### APPEAL SUMMARY

**Appeal ID:** 19041

**Project Address:** 631 SE Taylor St

**Building/Business Name:** The Rose Apartments

## LIFE SAFETY PLANS - APPEAL

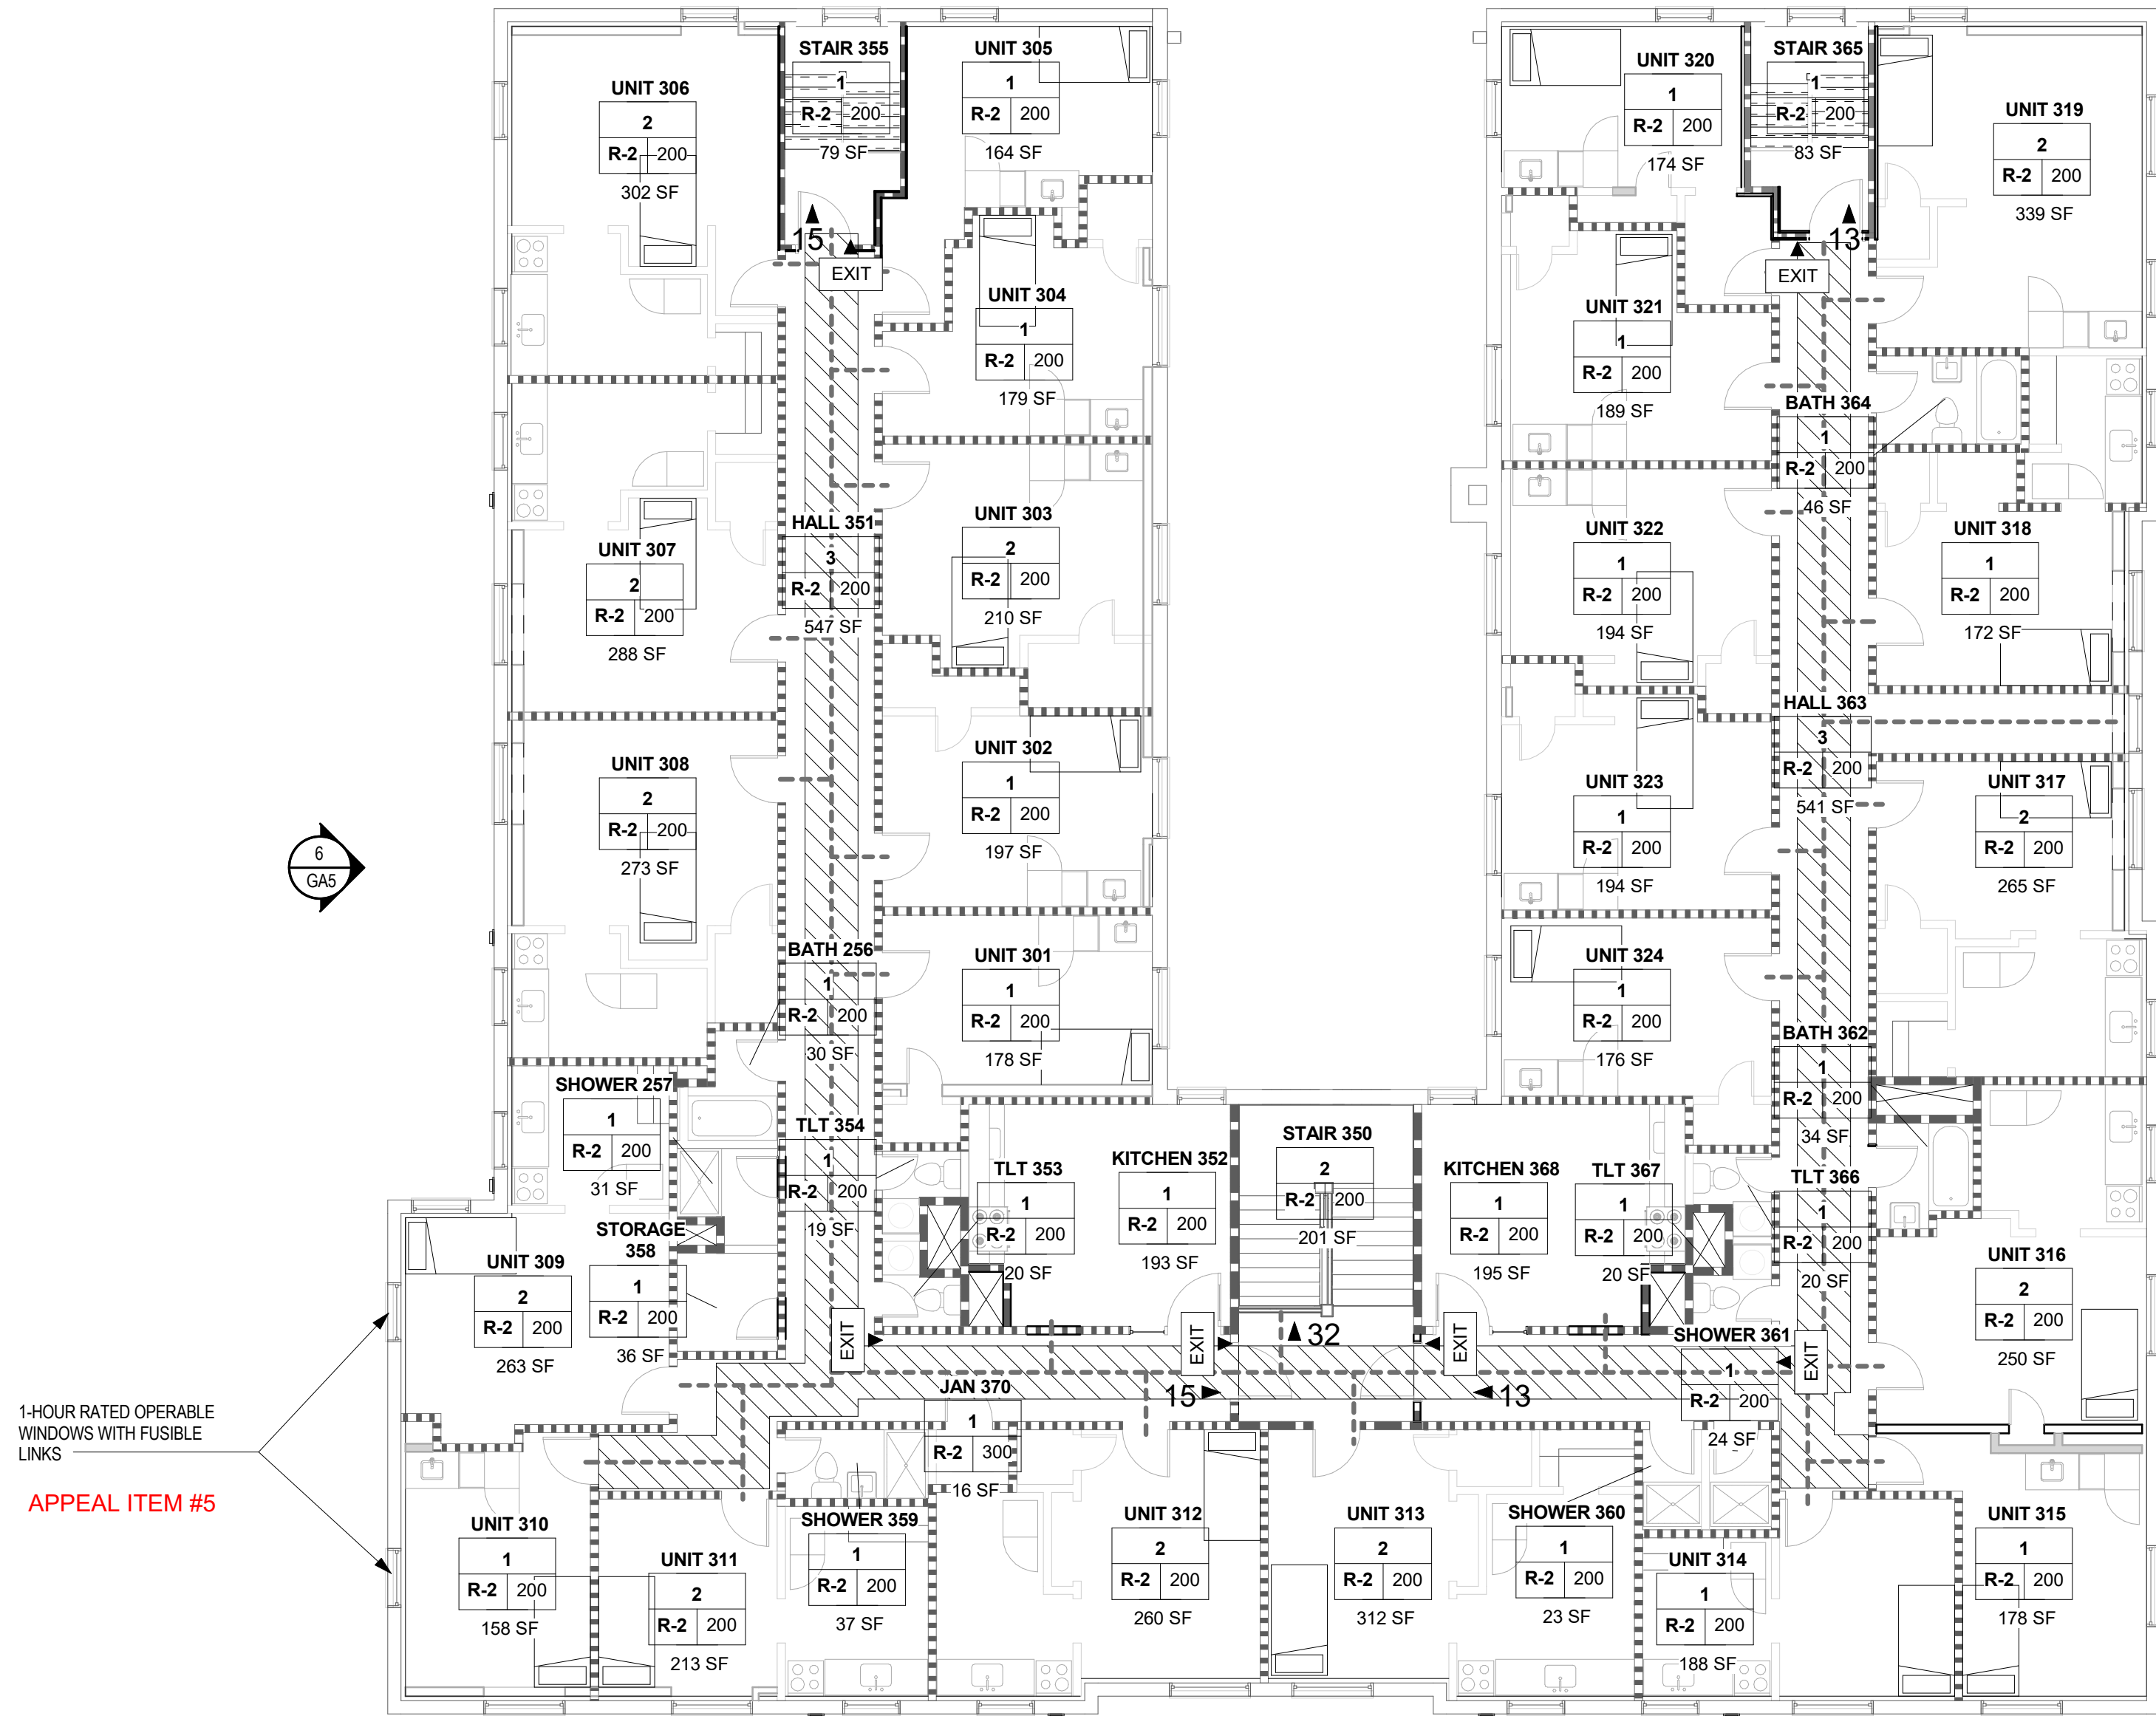
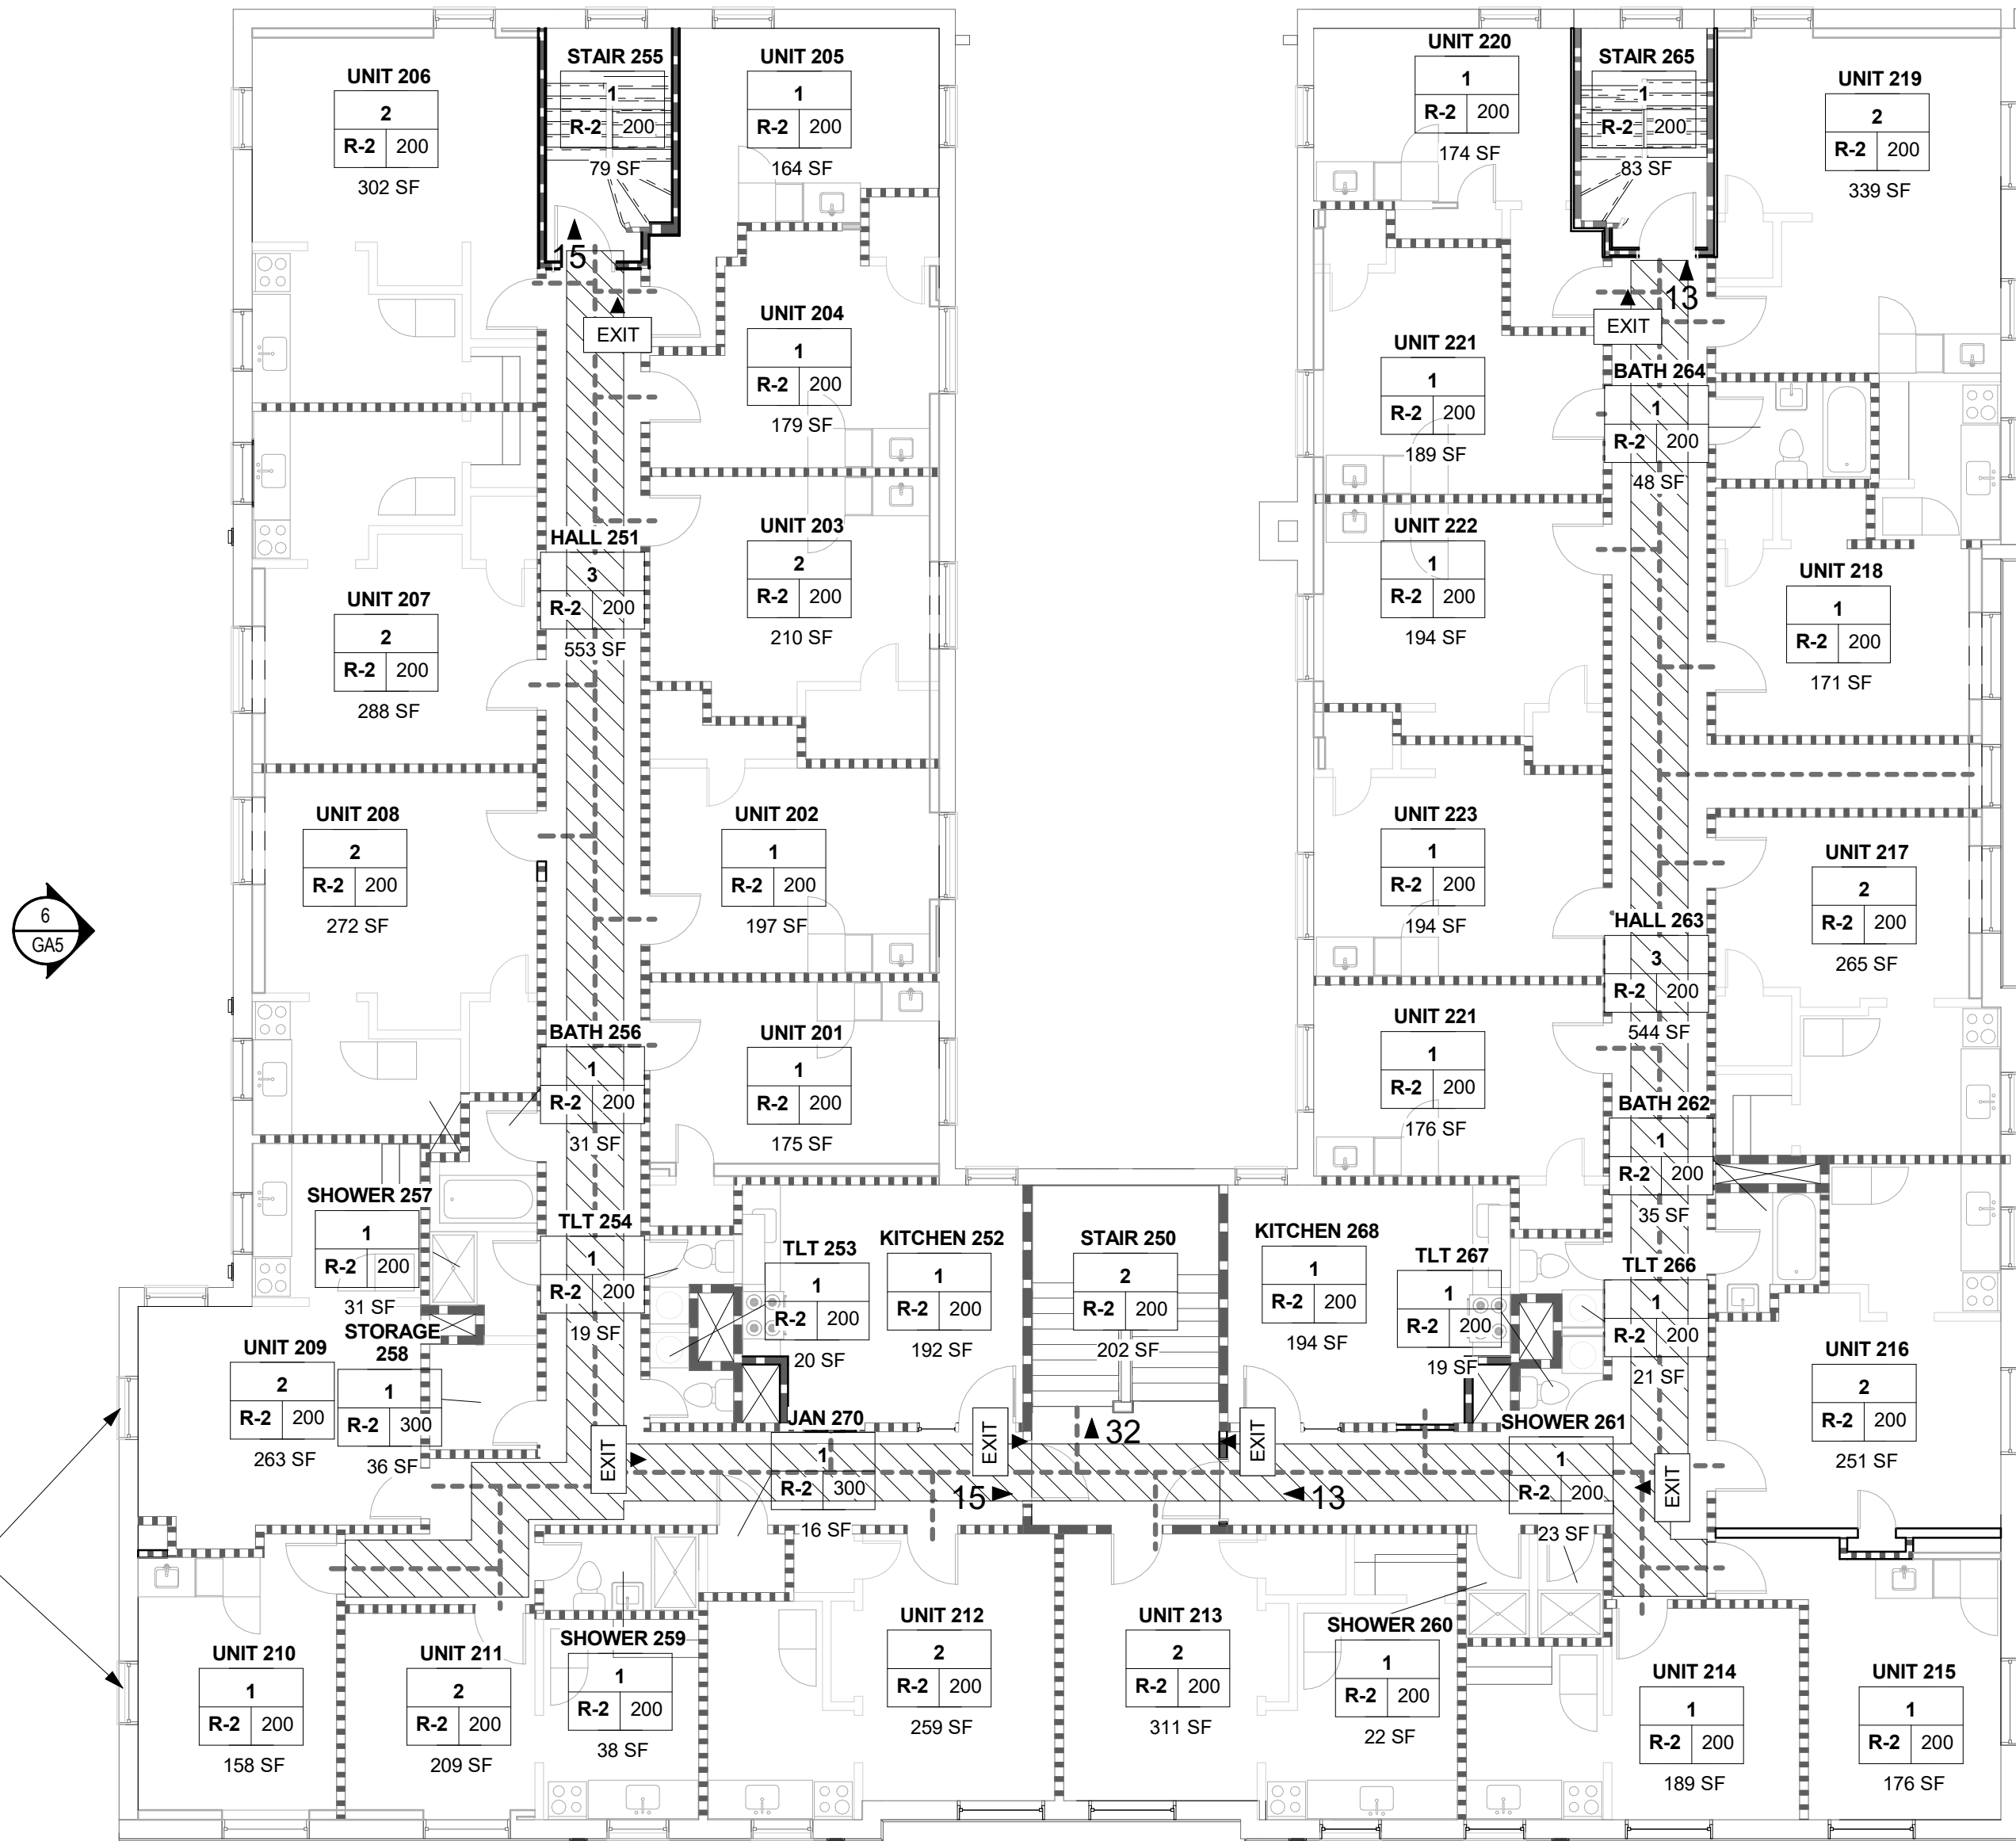
There is one existing ground story non-rated operable window along the western portion of the egress court (Unit 105). This window was approved by Appeal #6358. This window will be replaced with a UL listed ¾-hour fire-rated operable window with a fusible link that closes the window in the event of a fire. There are two existing ground story non-rated operable windows along the eastern portion of the egress court (Kitchen 124 and Food Pantry 123). These windows were approved by Appeal #6358. These windows will remain and be fixed in place, with additional sprinkler protection provided on the interior side. See Sheets GA2 and GA3.

<b>Code Section</b>	Table 705.8 Allowable Openings Based on Fire Separation Distance
<b>Requires</b>	Unprotected openings less than 3' from a property line are not permitted.
<b>Proposed Design</b>	<p>ORIGINAL APPEAL TEXT: The six unprotected operable windows at the west property line shall remain. The building shall be equipped with a full NFPA 13 sprinkler system throughout. See GA2 and GA3.</p> <p>RECONSIDERATION TEXT: The six unprotected operable windows at the west property line shall be replaced with UL listed 1-hour fire-rated operable windows with a fusible links that close the windows in the event of a fire. The building shall be equipped with a full NFPA 13 sprinkler system throughout. See GA2, GA3 and GA5.</p>

**1. Type 13 water curtain sprinkler protection at non-fire rated openings in exterior walls of egress court less than 10' in width: Granted provided windows are non-operable and sprinklers are spaced not more than 6 feet apart and placed a minimum of 6 inches and a maximum of 12 inches from the opening(s) and a maximum of 12 inches below the ceiling. Sprinklers are to be installed on the occupied side of the openings. A separate permit from the Fire Marshal's Office is required.**

**4. Unprotected windows at property line: Granted as proposed.**
